SECTION 96 SUBMISSION

DEE WHY RSL CLUB - 932 PITTWATER ROAD
STAGE 5 CLUB EXTENSION

THIS PLAN TO BE READ IN CONJUNCTION WITH
MOD2018/0119
NORTHERN BEACHES COUNCIL

PROJECT:
STAGE 5 - CLUB EXTENSION
PHASE 2 WORKS - SOUTHERN
CARPARK & ENCLOSURE

THIS PLAN TO BE READ IN CONJUNCTION WITH
MOD2018/0119
NORTHERN BEACHES COUNCIL

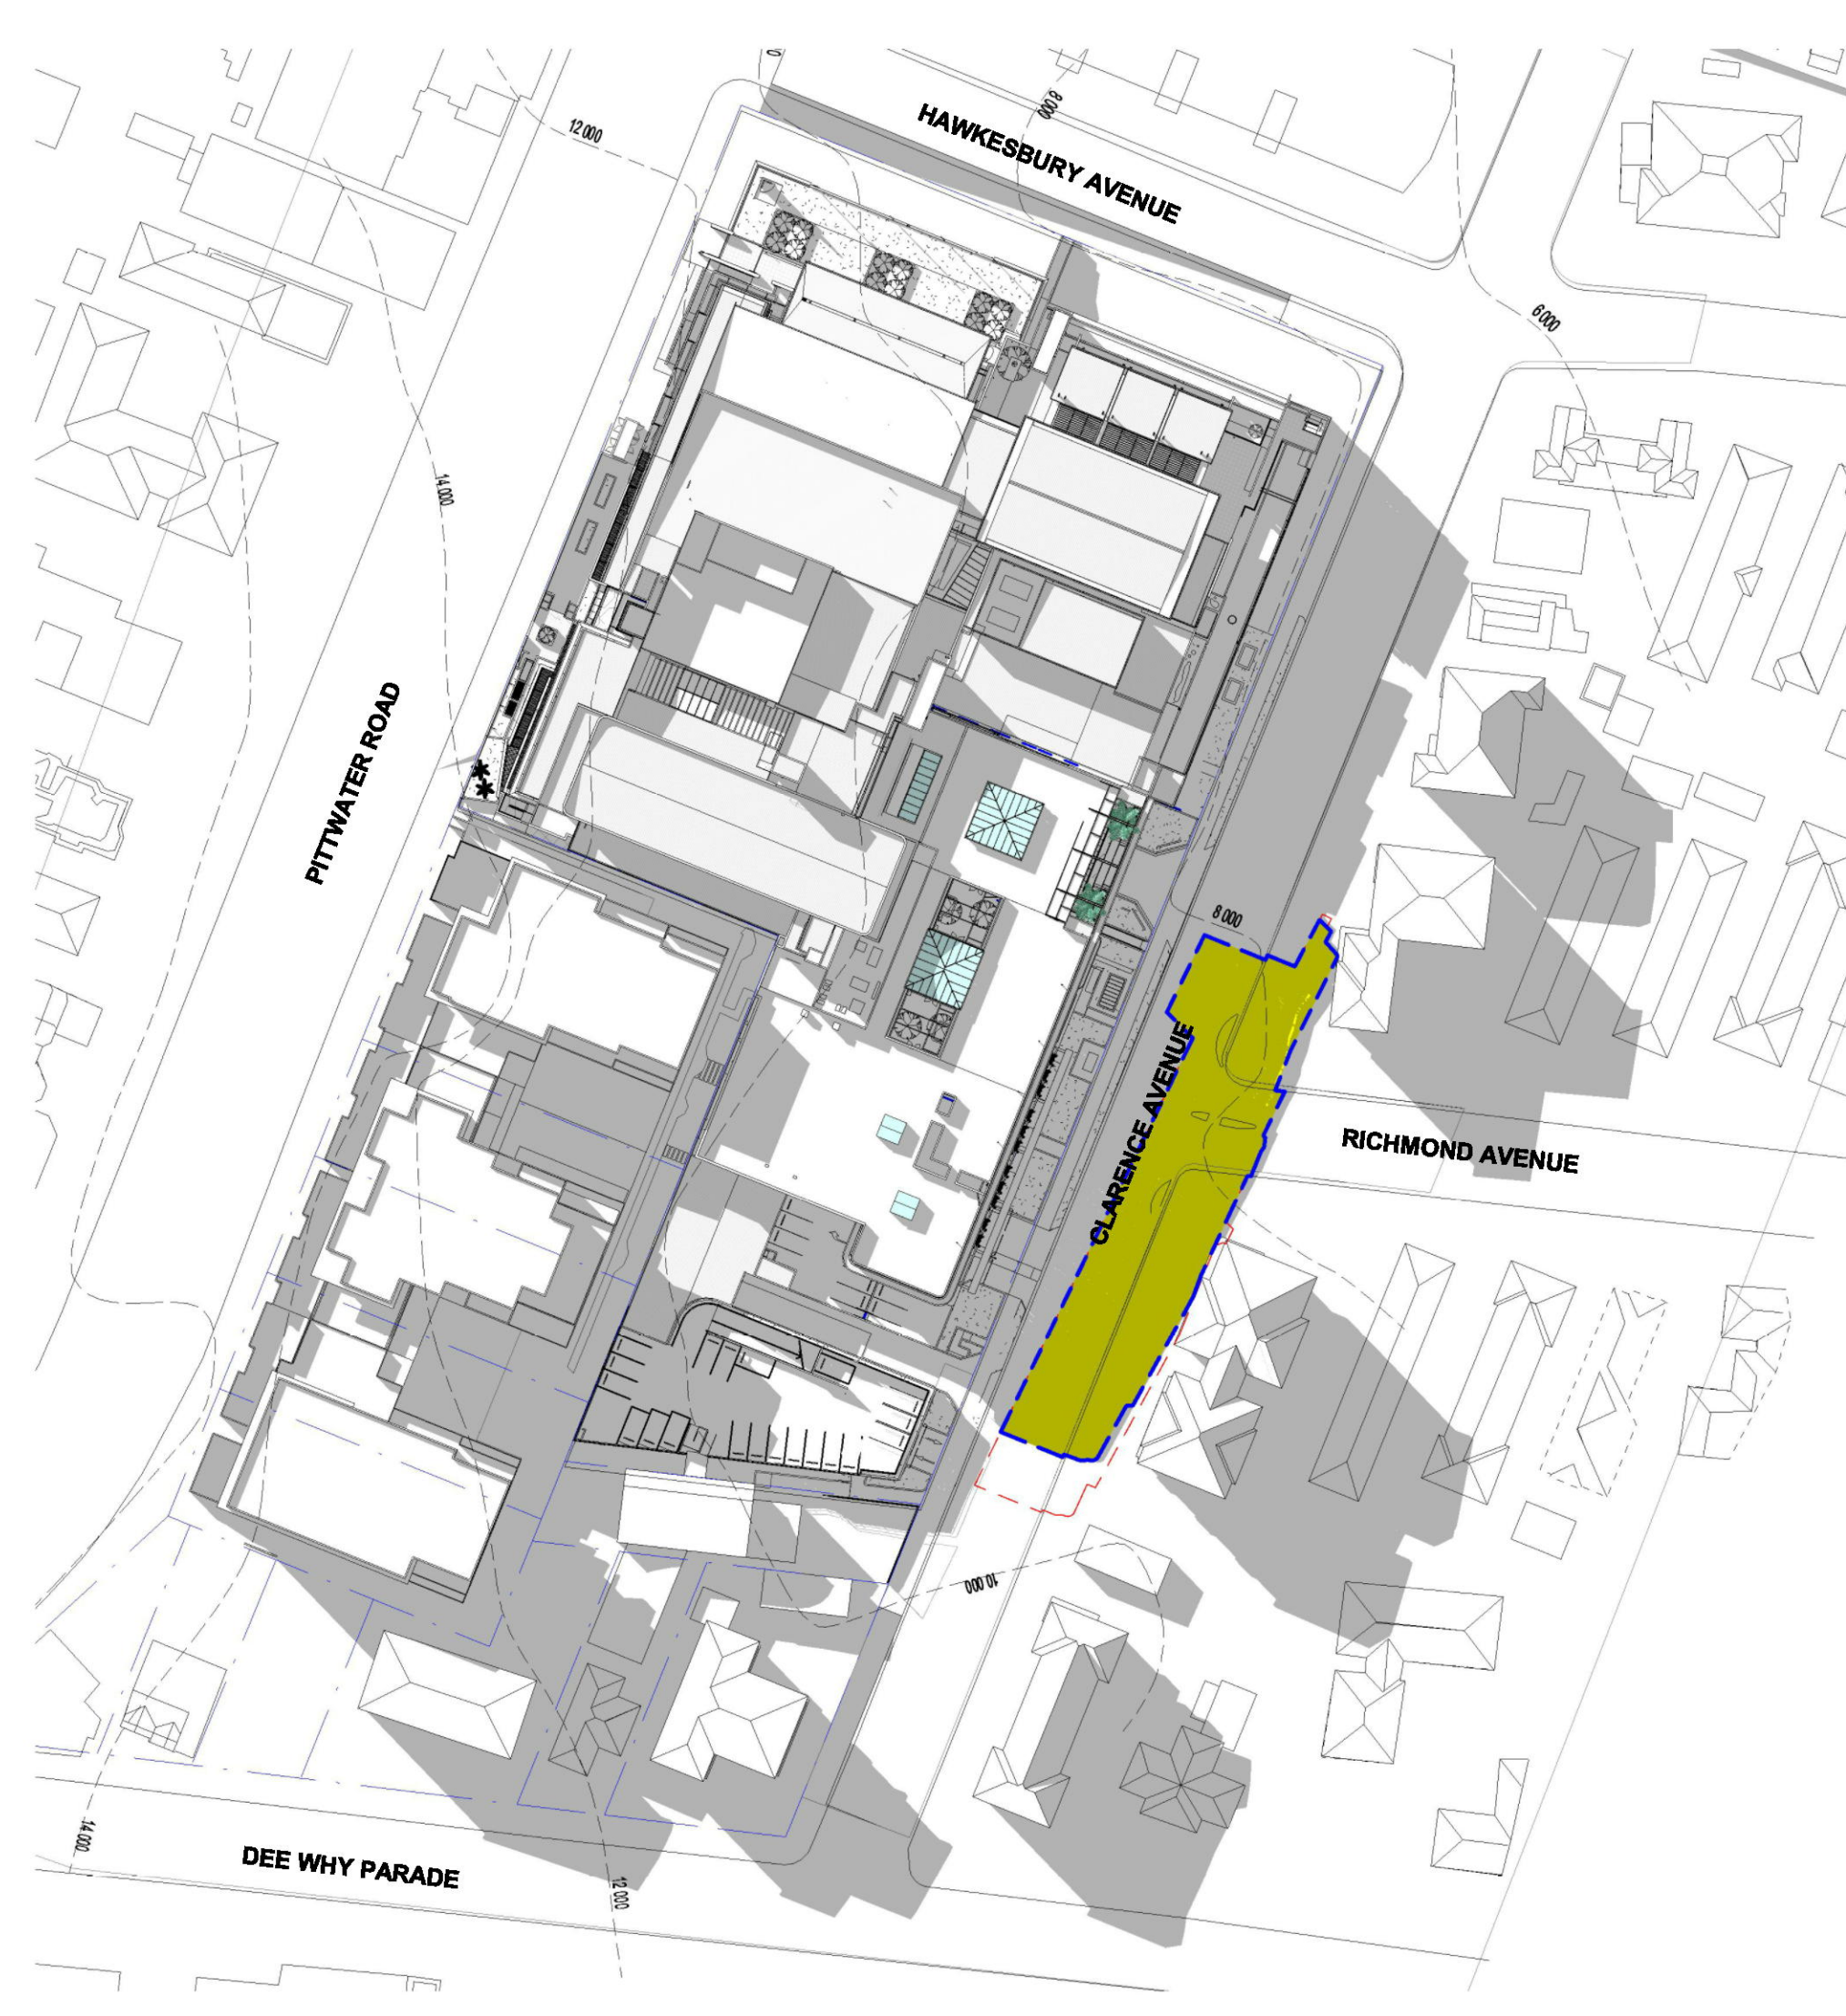
- SHADOW CAST BASED ON SECTION 96 MODIFICATIONS, REDUCED IMPACT
- SHADOW CAST ONTO SURROUNDING BY PROPOSED DEVELOPMENT AS PER ORIGINAL DA 2017/0244

DRAWING TITLE:
**CAR PARK LEVEL 1 (ENTRY LEVEL)
EXISTING AND DEMOLITION PLAN**

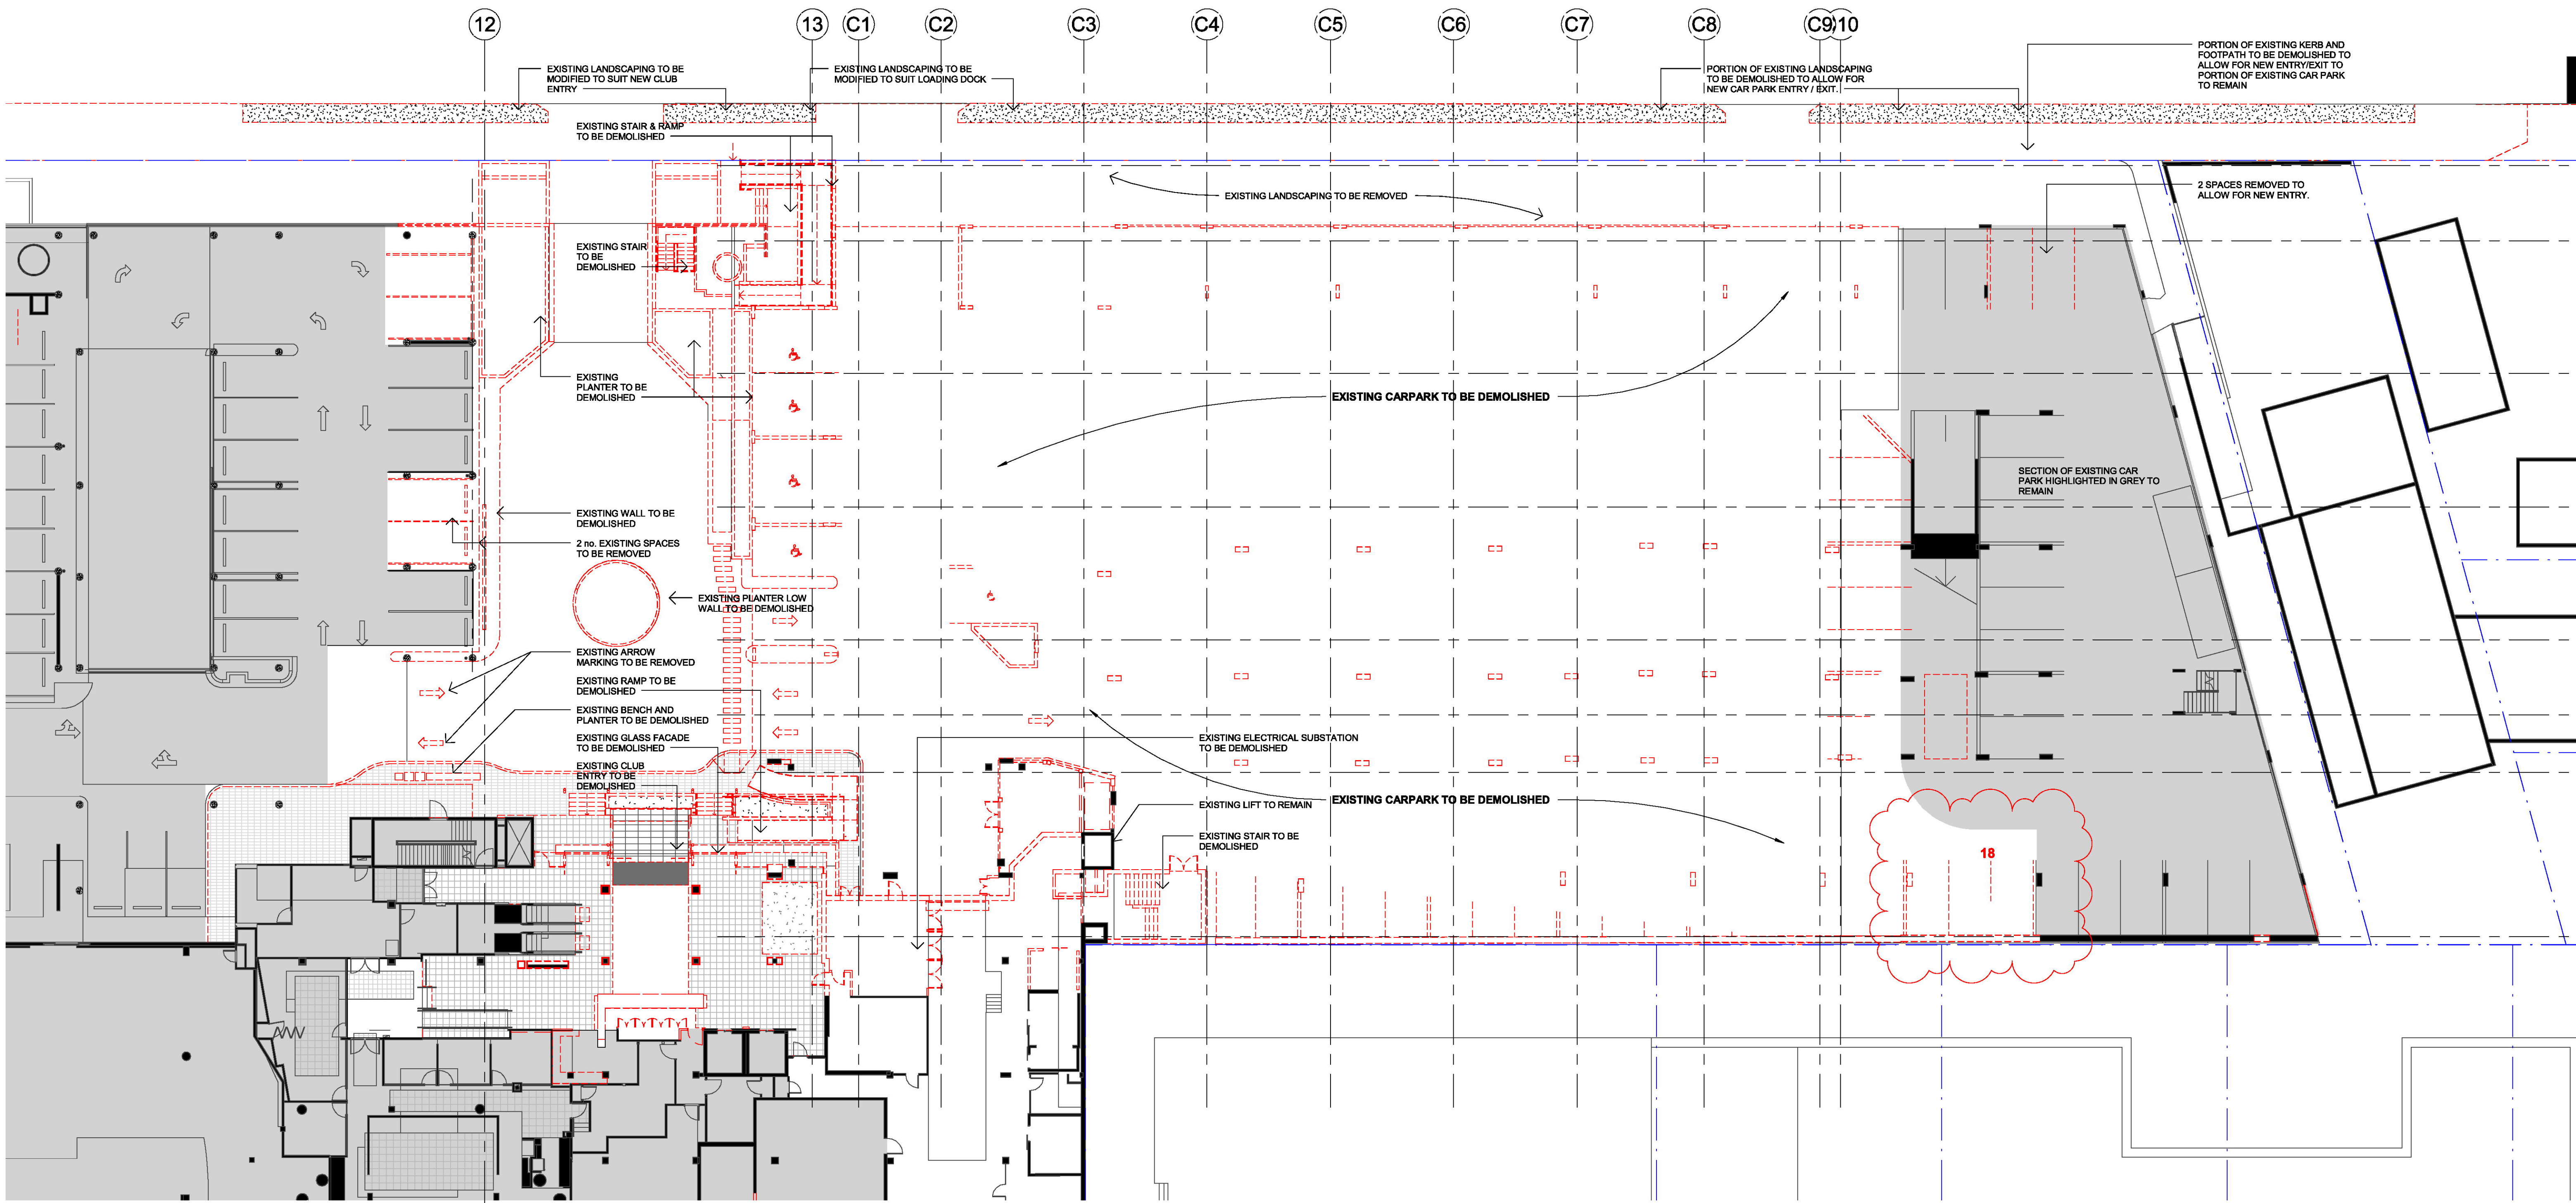
- CHANGES FOR SECTION 96 APPROVAL**
1. RELOCATED OPEN PLAN ROOM AT THE ROOF LEVEL
 2. MODIFIED ROOF OPENING ABOVE MAIN ENTRANCE
 3. MODIFIED CENTRAL SKYLIGHT (REDUCED HEIGHT, MODIFIED PITCH)

4. MODIFIED COURTYARD: TWO OPEN COURTYARDS AND ONE SKYLIGHT COVERED AREA INSTEAD OF ONE LARGE GLASS ROOF. REDUCED HEIGHT AND PITCH
 5. MODIFIED SMOKING TERRACE: ROOF OPENING, SIZE AND PLANTED AREA. AREA REDUCED BY 21m²

6. REDUCED NUMBER OF ROOF SKYLIGHTS ABOVE ASIAN RESTAURANT: 2 INSTEAD OF 6 TO SUIT THE NEW INTERNAL LAYOUT
 7. MODIFIED EXIT STAIR: POSITION, CONFIGURATION, METAL ROOF NO LONGER REQUIRED

10. NEW ACOUSTIC METAL ROOF ABOVE REVISED LOADING DOCK
- facade**
11. MODIFIED FACADE APPEARANCE DUE TO CHANGES IN THE CAR PARK LEVELS, LOADING DOCK AND EGRESS STAIRS

12. REMOVED LOUVRES ON THE BACK FACADE (WESTERN FACADE) DUE TO MECHANICAL RISER NO LONGER REQUIRED / REVISED LOCATION FOR EGRESS DOORS
 13. 2m WIDE INTERNAL EGRESS STAIR MODIFIED INTO TWO 1m WIDE EXTERNAL STAIRS WITH DECORATIVE BALUSTRADES

14. EXTENT OF LEVEL 2 (MAIN TRADING LEVEL) REDUCED BY 8326mm FROM THE SOUTHERN BOUNDARY AND INCREASED BY 1100mm TO THE EASTERN BOUNDARY
 15. MODIFIED FACADE CURTAIN WALL. MULLION BLADES

18. REVISED LOADING DOCK ENTRANCE AND LOCATION/ ENLARGED DEMOLISHED AREA IN THE EXISTING RETAINED SOUTHERN CAR PARK
 19. NEW / MODIFIED EGRESS PATHS FROM EXISTING CARPARK LEVEL -1, NEW CARPARK LEVEL 1,

20. RELOCATED ELECTRICAL SUBSTATION / LANDSCAPED AREA MOVED TO SUIT
 21. MEDIAN STRIP ADDED AT ENTRY TO PROVIDE PLACE OF REFUGE AND ENSURE WIDTH OF ENTRY/ EXIT IS LESS THAN 8M AS PER DA CONDITION 23

24. BASEMENT CAR PARK LEVEL -5 ADDED.
 25. CAR PARK ENTRY / EXIT MOVED TOWARD NORTH BY 3044mm
 26. PLANTER MODIFIED ON THE BACK (WESTERN) FACADE DUE TO REDUCTION OF THE MAIN TRADING FLOOR SLAB

27. LOCATION OF AIR INTAKE MODIFIED
 28. EXTENT OF RESTAURANT REDUCED BY 136m²
 29. CLUB ENTRANCE ACCESSIBLE RAMPS MODIFIED
 30. ONE ADDITIONAL EXISTING CAR PARK SPACE TO BE REMOVED FROM EXISTING NORTHERN CAR PARK

31. SOLID MASONRY WALL ADDED BETWEEN EXISTING ZONE D CAR PARK AND LOADING DOCK ACCESS.
